Herschel

Abs./Sender:	Horst Faas
Abt./Dep.:	ED 37/Herschel
Tel./Phone:	+49 75 45 8-3990
Fax/Fax:	+49 75 45 8-42 43
E-Mail:	Horst.Faas@astrium-space.com
Ref.:	HP-ASED-FX-0727-02

Betreff/Subj.: Comments on Spire hoisting devices – Impact on the ASED instrument integration

Annex 1

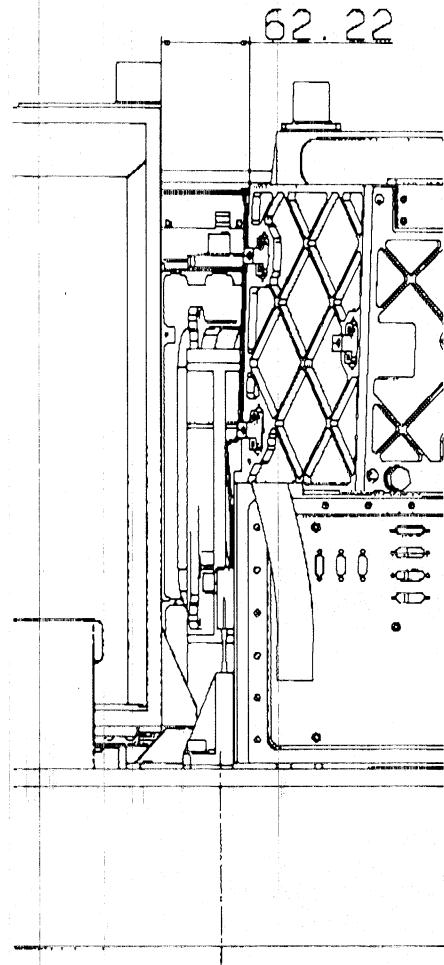
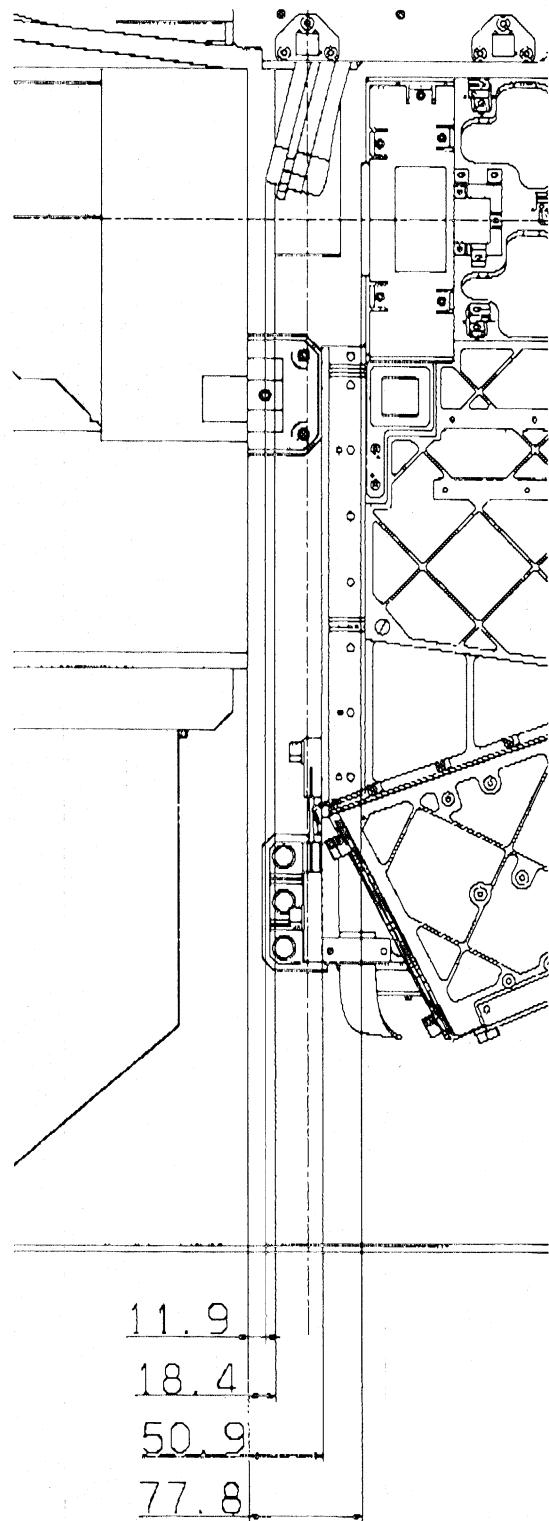
- ASED does not see the need to use protection frames for the cone foot and the A-frames. For the Spire CQM and FM integration a crane with a lowering rate of 3 mm/sec will be used. Additionally, a hydaset can be used which would allow to further reduce the lowering rate. Furthermore, the SPIRE cone foot protection on the +z-side of the SPIRE FPU requires min. 50 mm of space between the SPIRE and PACS FPU, which is not available, if PACS is already installed. Annex 1 shows a top view and a side view (from +y direction towards HIFI). Note: I/F drawings will be sent as well by email.

Annex 2

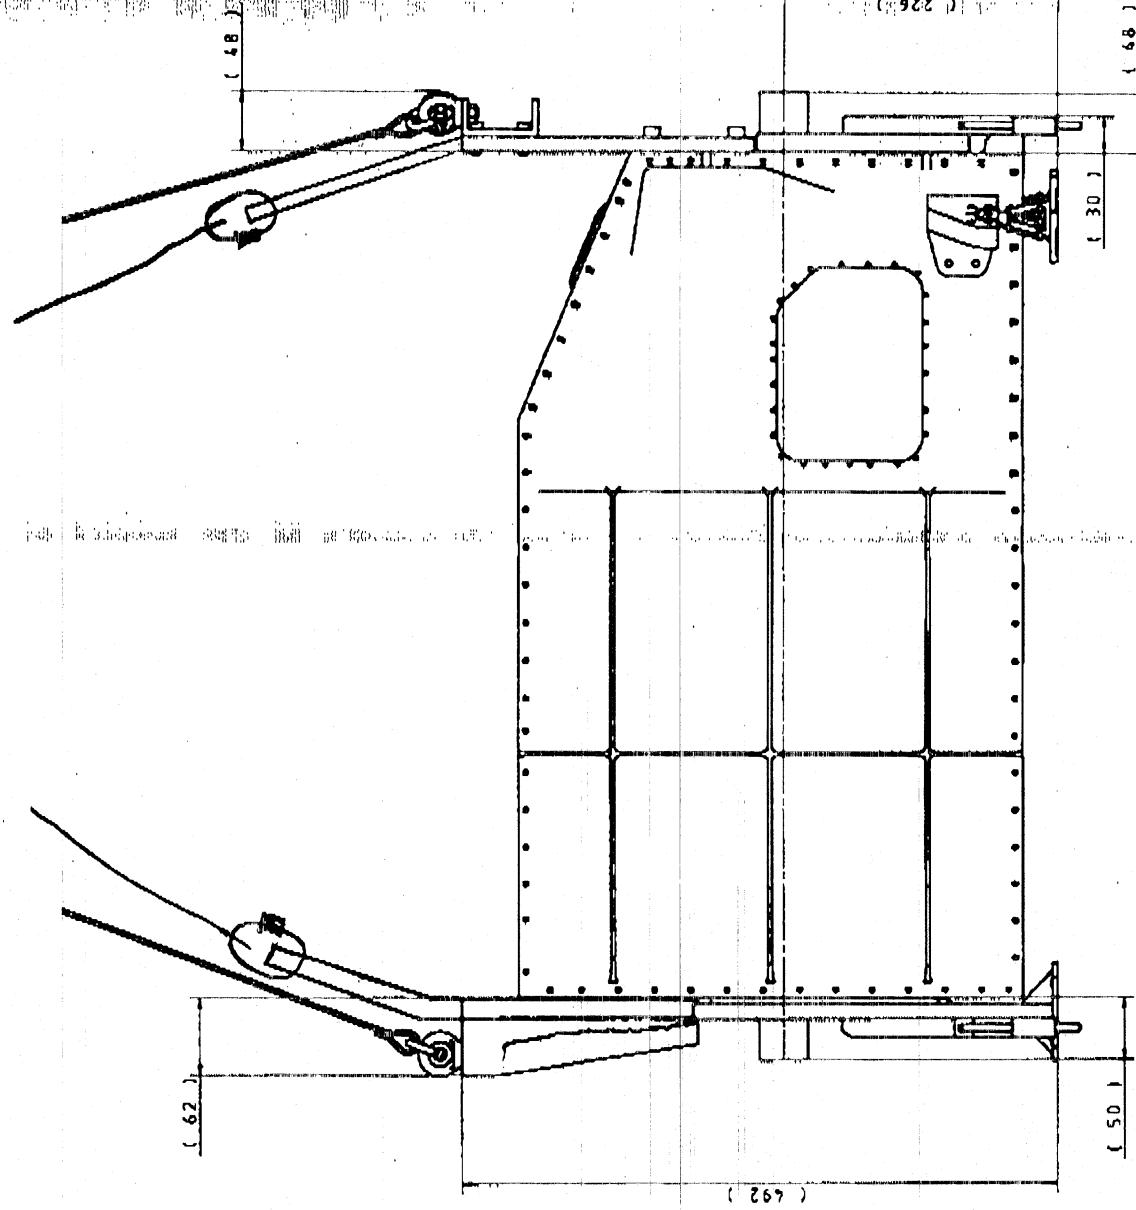
- ASED would propose to simplify the FPU hoisting device on the +z-side of the SPIRE FPU from the current U-Frame design to a fish plate design with a hole for a shackle. This would have the further advantage that minimum momentum is transferred to the FPU. See modified hoisting device drawing attached as Annex 2.
- FPU Level-0 Thermal straps side: Please clarify if the Level-0 thermal straps will be pre-mounted or will be fixed following the FPU integration on the Herschel OB. Background: Clearance between Level-0 Detector thermal strap and the Level-1 ventline is minimal and the details for FPU integration need to be checked. Astrium has agreed at the Mech. IF Mtg. in September to deliver an Herschel OBA STEP file to support this activity.
- Detailed I/F drawings of the FPU cone foot (e.g. overall height) are required by ASED to clarify details of the integration procedure.
